REQUEST FOR INFORMATION **DATE:** May 11, 2016 **NO.:** RFI-071

Project Name: Webster University Interdisciplinary Science Building Project No.: 15051

Subject: Level 0 vent connections

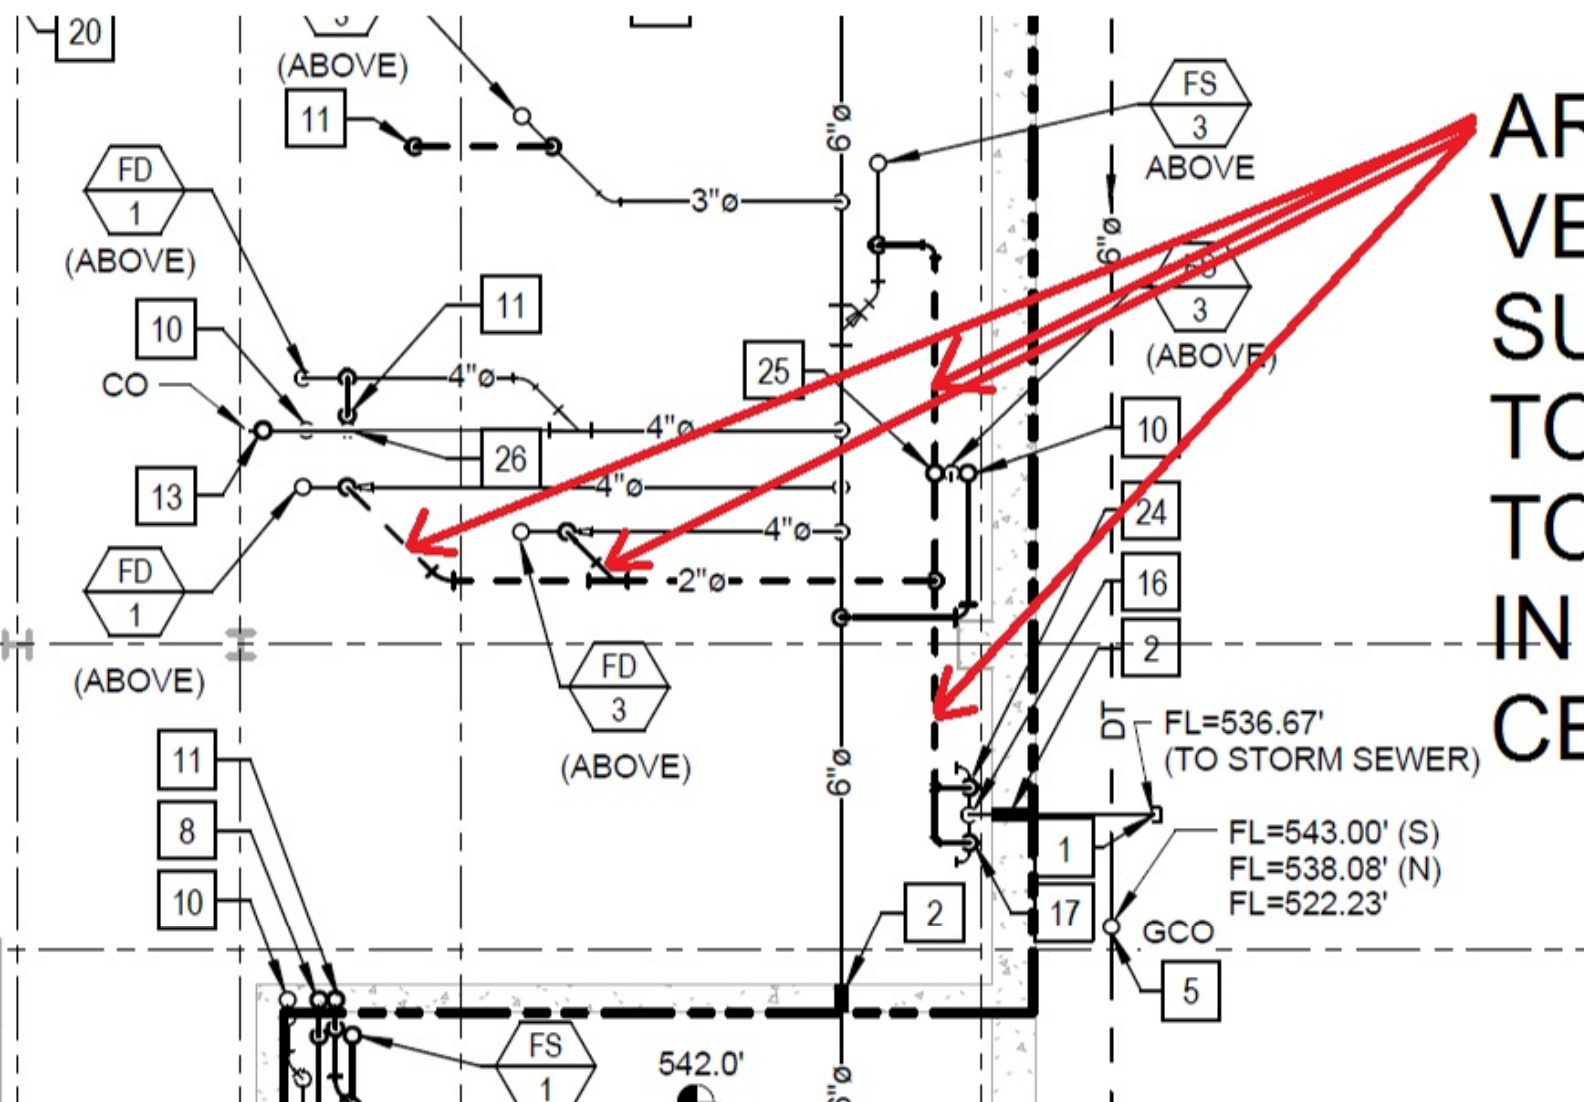
Plumbing plan for L0 ceiling shows several vents combining in the L0 ceiling near D-8: three floor drain vents, and the vent from the draintile basin. Please confirm that these vents are indeed supposed to connect together in L0 ceiling, since it appears to be below the flood rim level of the floor drains. See attached sketch.

ARE THESE
VENTS
SUPPOSED
TO ALL TIE
TOGETHER
IN LEVEL 0
CEILING?

The three vents from the floor drains will be modified to turn up to Level 1 and make the tie-ins on that level.
This will be addressed in an up-coming addendum.
